**A DIGITAL ELEVATION MODEL to COMPARE the EXISTING DUNES at SEAPOINTE VILLAGE,
with the US ARMY CORPS of ENGINEERS HEREFORD INLET TO CAPE MAY INLET SHORE
PROTECTION PROJECT LOCATED in TOWNSHIP OF LOWER, CAPE MAY COUNTY, NJ**

Prepared for the Seapointe Village Owners Association

**Prepared by the Stockton University Coastal Research Center (CRC), 30 Wilson Ave, Port Republic, NJ
08241**

September 12, 2015

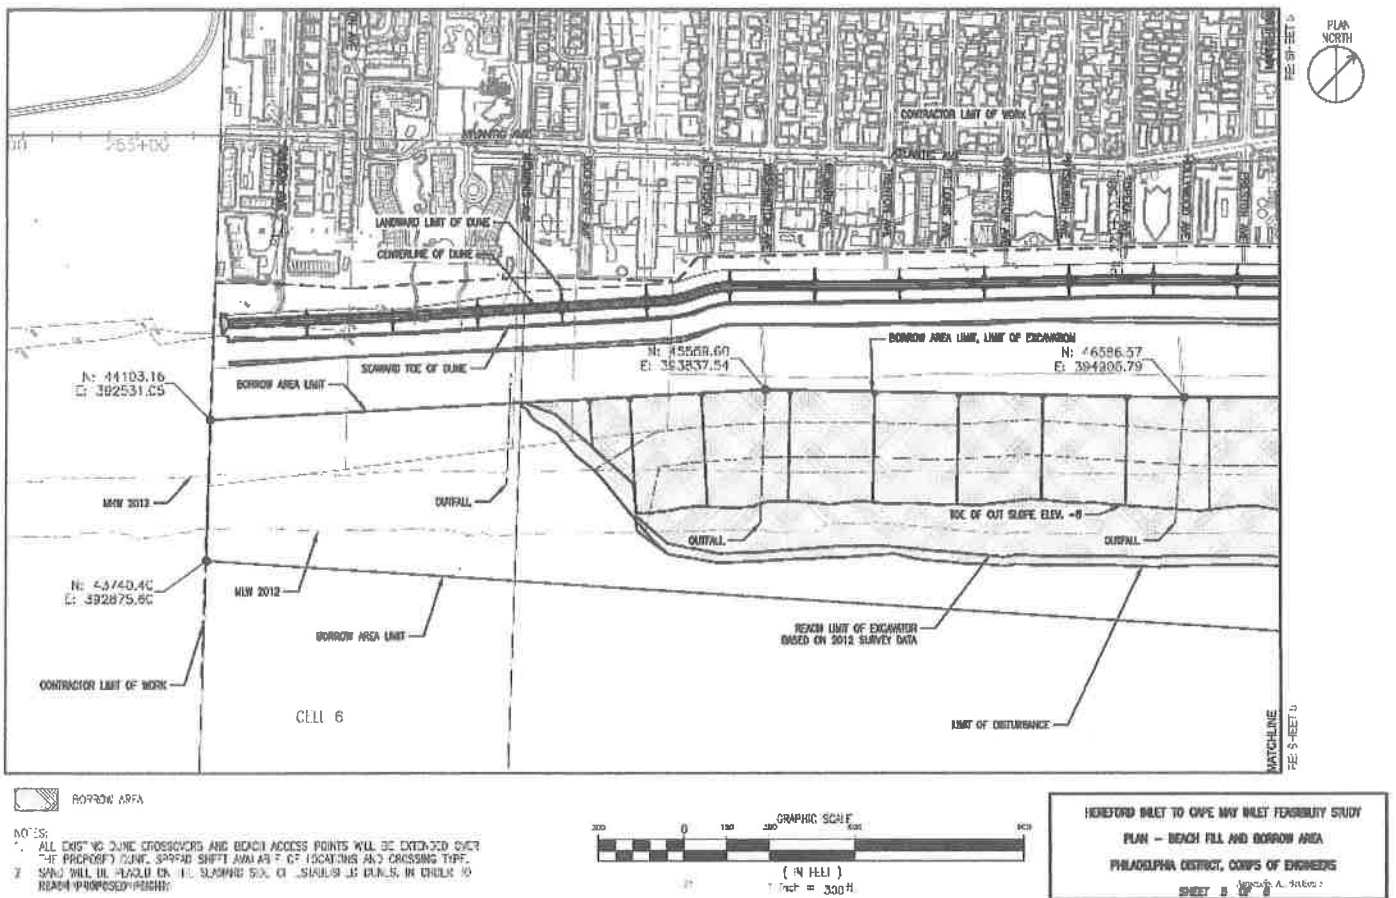
- A. The zone of sand excavation for the project ends at Memphis Avenue just north of Seapointe Village. Therefore, no existing sand is destined for removal from the Seapointe beachfront. In fact, recent changes to the erosional behavior in North Wildwood may mean the end point for project sand excavation occurs in Wildwood Crest.
- B. The proposed plan for the Lower Township portion is basically to create a consistent elevation and width dune along the beachfront as wave damage protection should a serious northeast storm or hurricane occur during the project timeframe of 50 years.

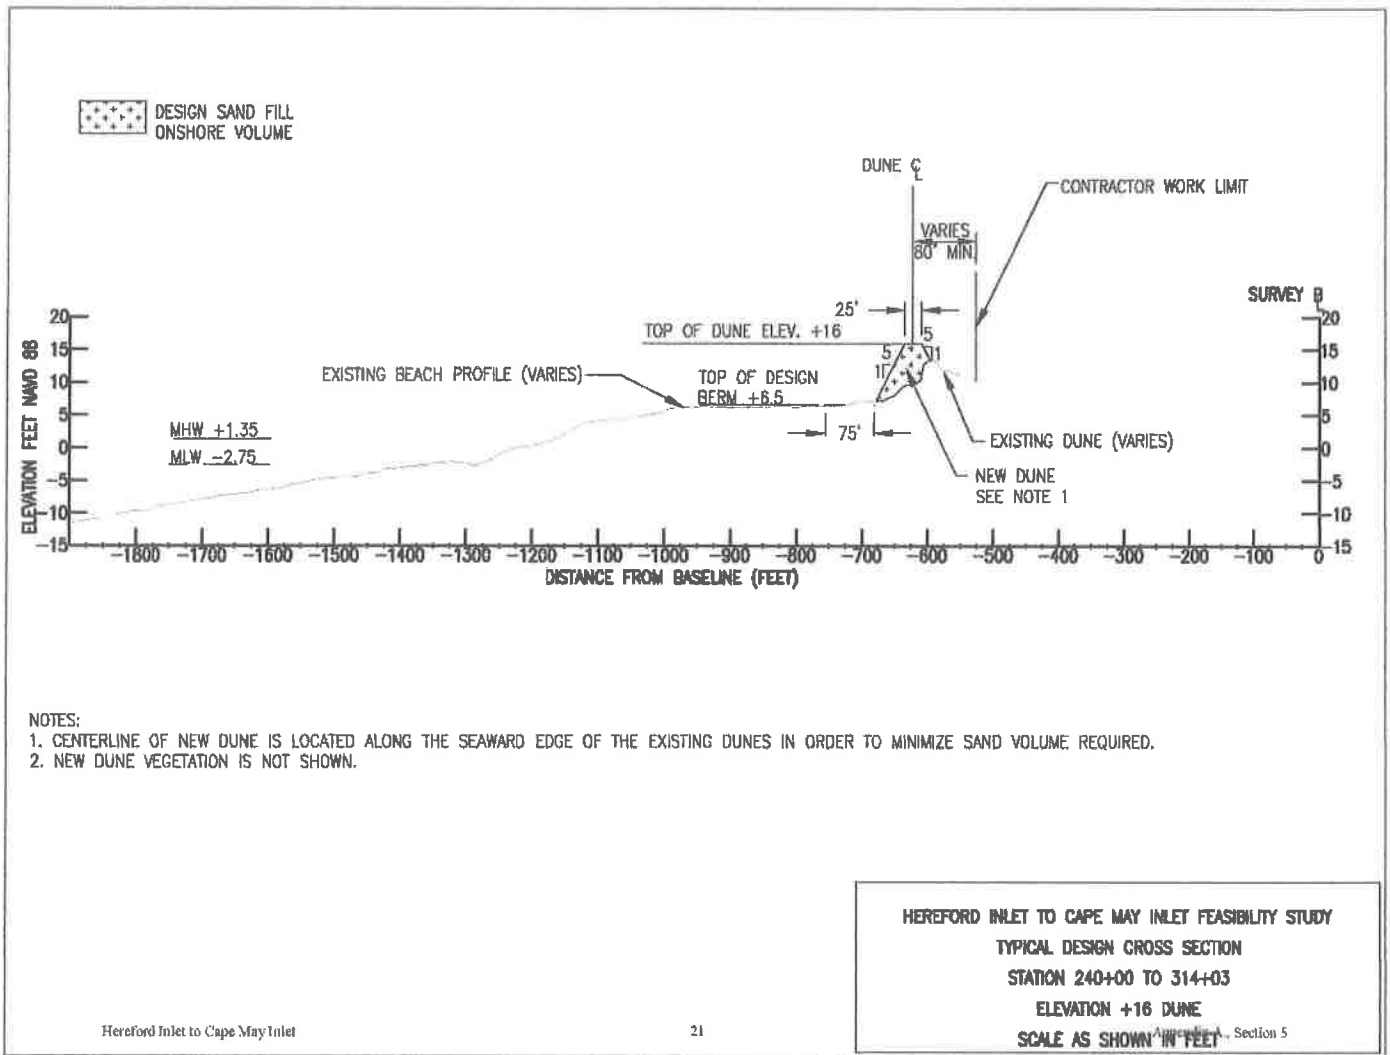
The feasibility study’s text describes the proposed dune enhancement work as occurring seaward of the existing crest elevation to either (a), raise the existing elevation to 16.0 feet NAVD 1988, or (b), widen the crest so that 25 feet of surface width is at least at a 16.0 foot elevation. Should the existing dune cross section actually MEET the design criteria of elevation and crest width, then no further work would be undertaken. Why re-do what nature or the property owner has already created?

At the initial meeting, the team observed that likely the only deficit in the Seapointe Village dune system would be the two beach access pathways extending from the landscaped pool area onto the beach bracketing the luncheon facility immediately seaward of the dune toe. Likewise the Memphis Avenue street end at the beach lacks any dune, so this would also need to be constructed to the design parameters. The project plans include

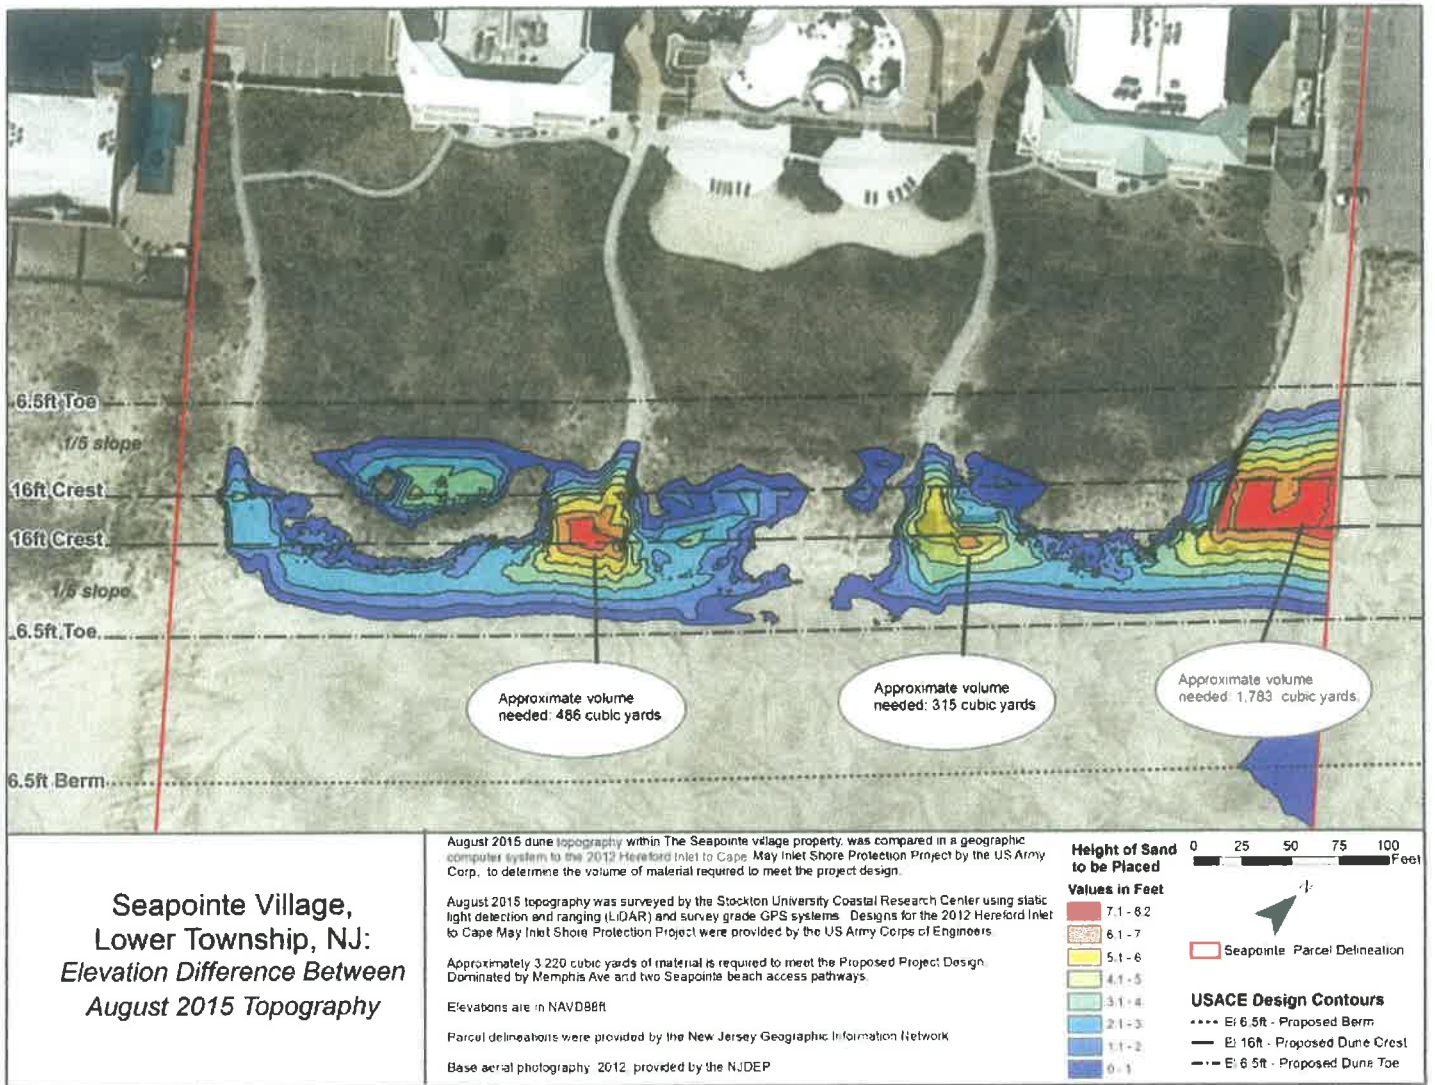
The map shown below is the compilation of the proposed dune with its crest, landward and seaward toe bases shown as dashed black lines (elevation to the left) and the existing Seapointe Village dune system. Areas where the existing dune exceeds the US Army design simply show as the air photograph view of the ground surface. The colors represent regions where the existing dune is deficient in elevation compared to the design plan. The yellow and orange colors represent the spots with the highest deficiency and are located on the "beach grade" public pathways to the beach through the dunes. Each of the two private Seapointe paths are low as is the Memphis Avenue public access path at the street end.

Memphis Avenue would require the most sand added (1,783 cubic yards on just the Seapointe portion) to achieve the design dune cross section, while the south path is far less at 486 cubic yards, and the north path is the least deficient at 315 cubic yards. A minor sand volume (636 cubic yards) would need to be added to the seaward dune slope along much of the property, but at 1- to 3-foot thicknesses at the most. Currently this zone has very sparse vegetation, so the added sand would have little environmental impact. The total deficiency amounts to 3,220 cubic yards of added sand, nearly all on the pathways or seaward dune slope. This represents 22.1% of the entire federal dune design for this property (14,540 cubic yards) above the 6.5-foot elevation of the existing beach had there been no existing dune at all.
